HONOR CHARTER
ACADEMY
BENT GRASS MEADOWS DRIVE
PEYTON, CO

SCHEMATIC
LANDSCAPE
PLANTING PLAN

V3_Landscape Plan drawings.pdf Markup Summary

LP-1

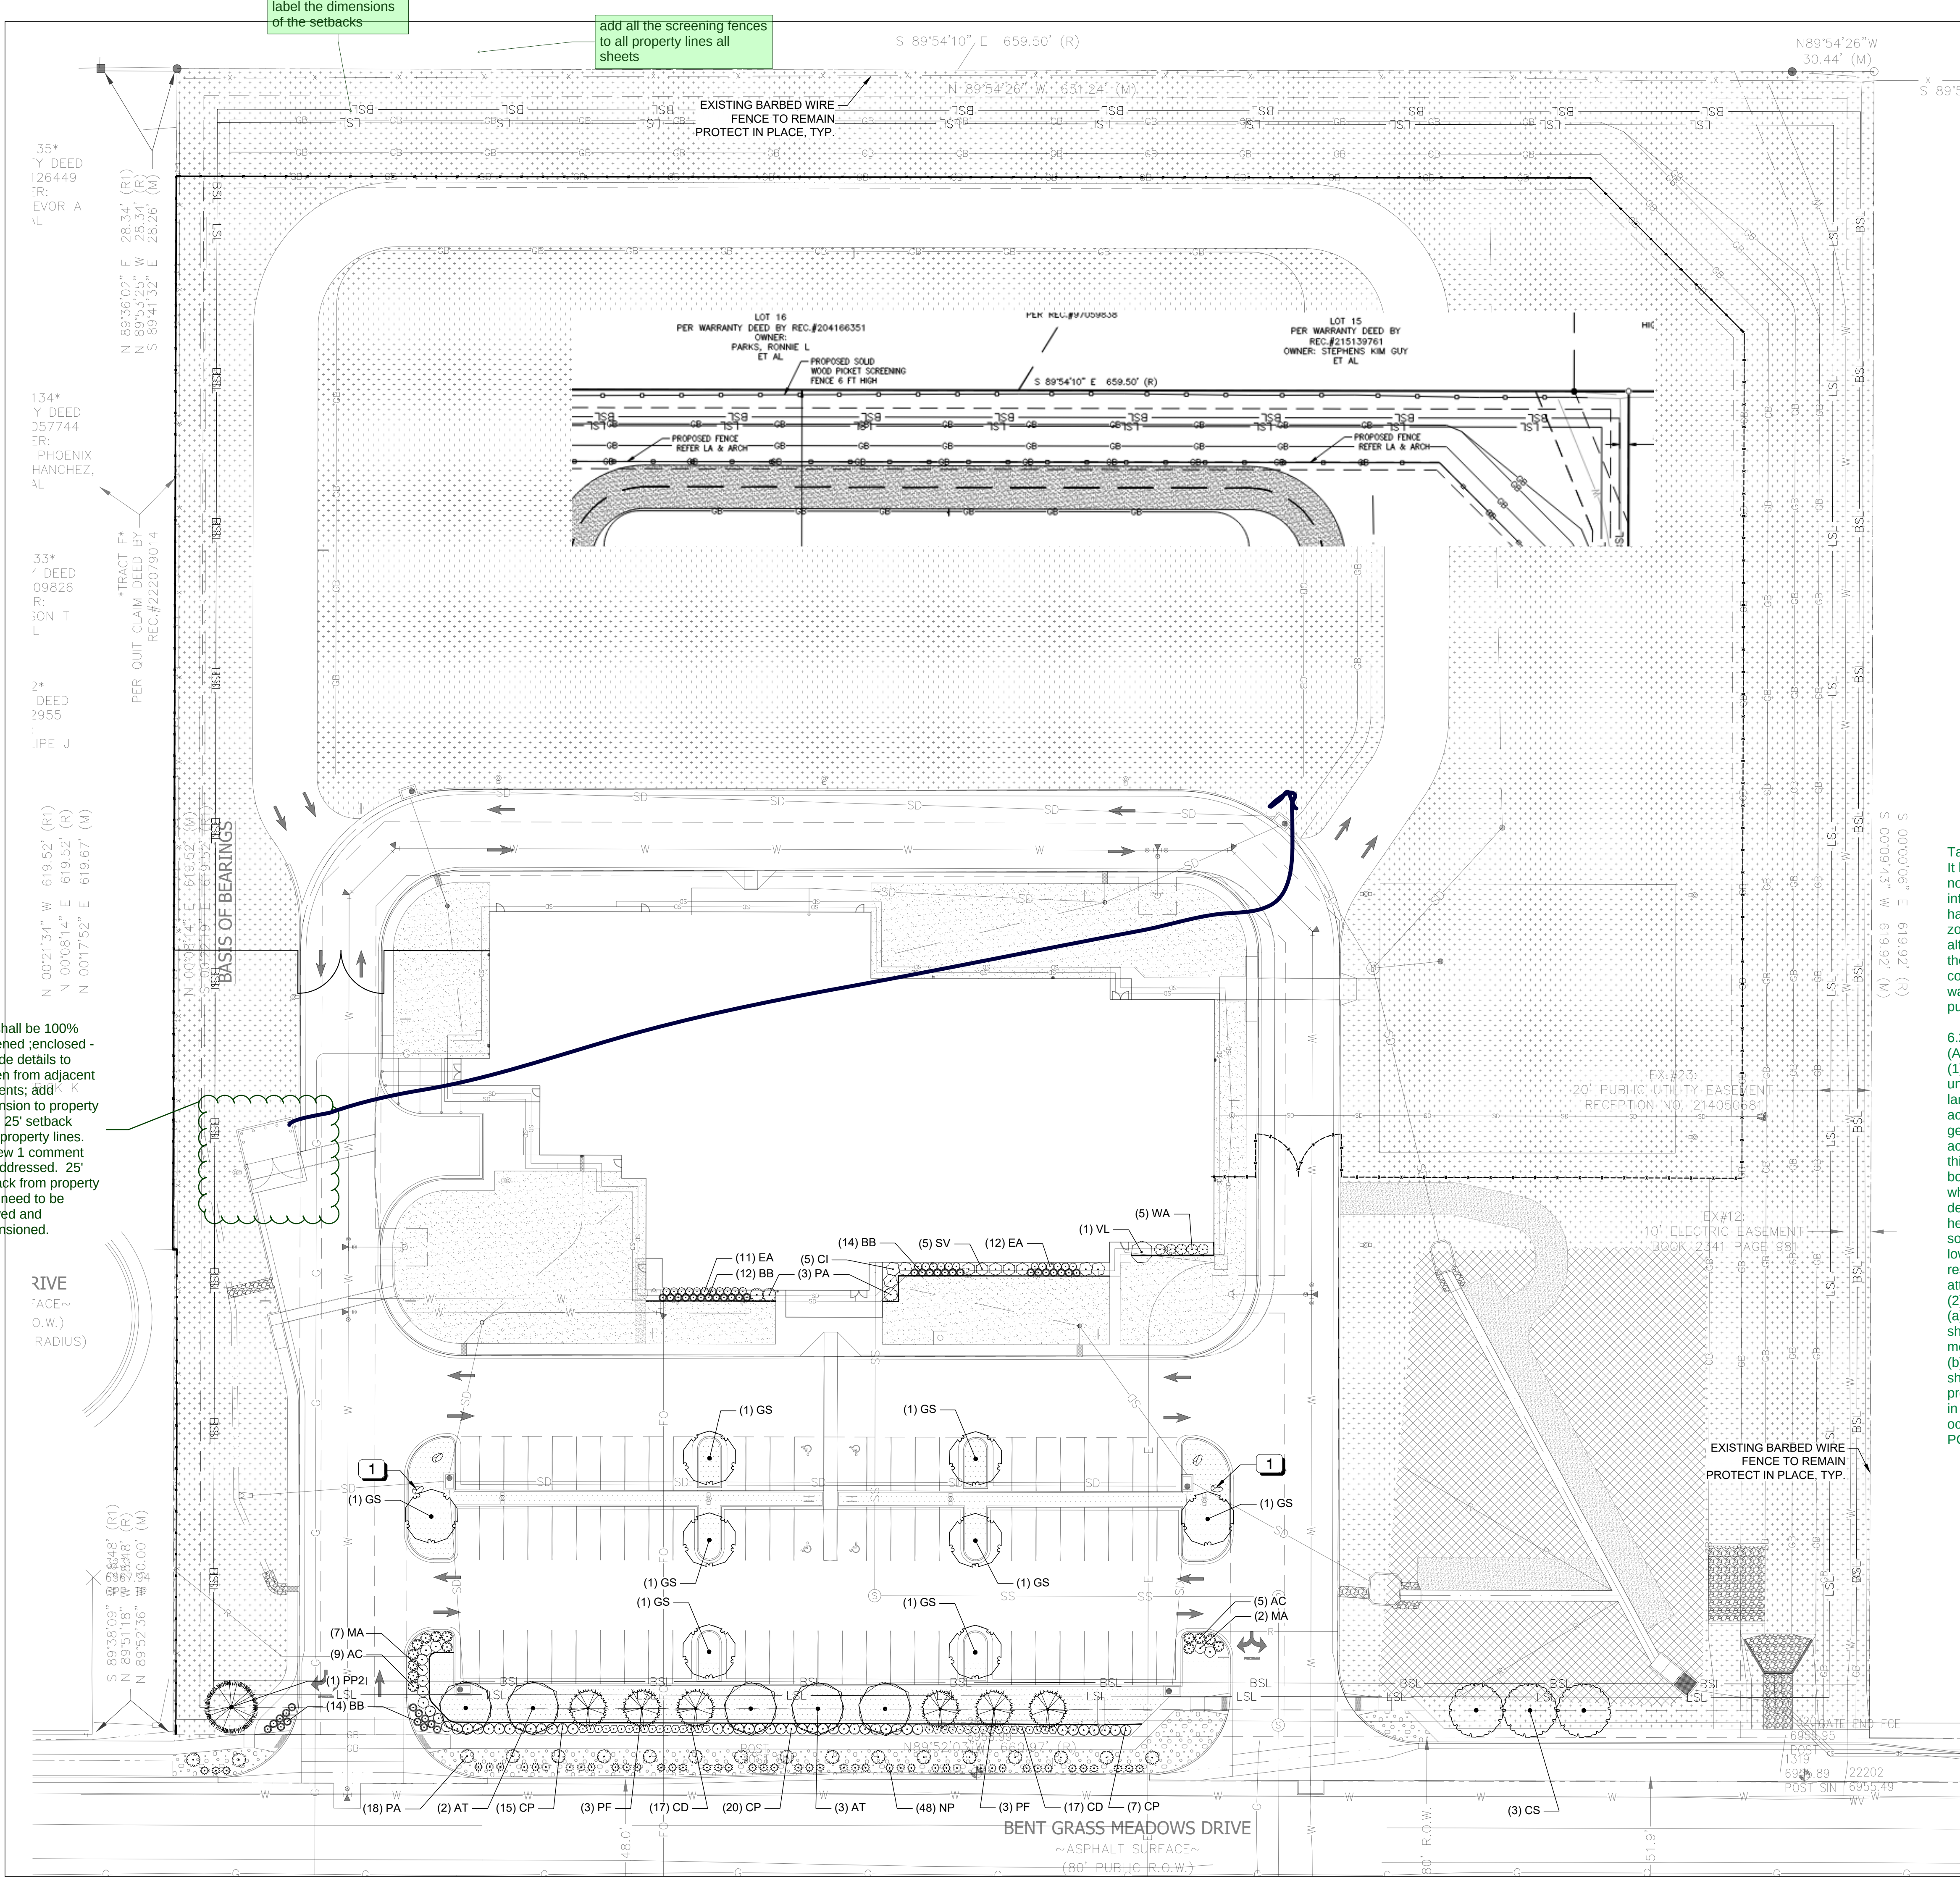
Provide the alternative justification for each area you are omitting landscape from please

Tammy-
It looks like the landscape plan didn't address comments; it does not meet the standards in the Code for buffers, roadway and internal landscape. There is mention of tree credits? We don't have tree credits that I am aware of. A school is not exempt from zoning as indicated on the Plan. Are you proposing an alternative/substitute landscape plan? If so, you will need to state the justification in the table on the Plan. I am sending you my comments on the landscape plan via email so you don't have to wait until the remainder comments on other documents are published, so you can make adjustments.

this shall be 100% screened ,enclosed - provide details to screen from adjacent residents; add dimension to property lines; 25' setback from property lines. Review 1 comment not addressed. 25' setback from property lines need to be showed and dimensioned.

label the dimensions of the setbacks

add all the screening fences to all property lines all sheets
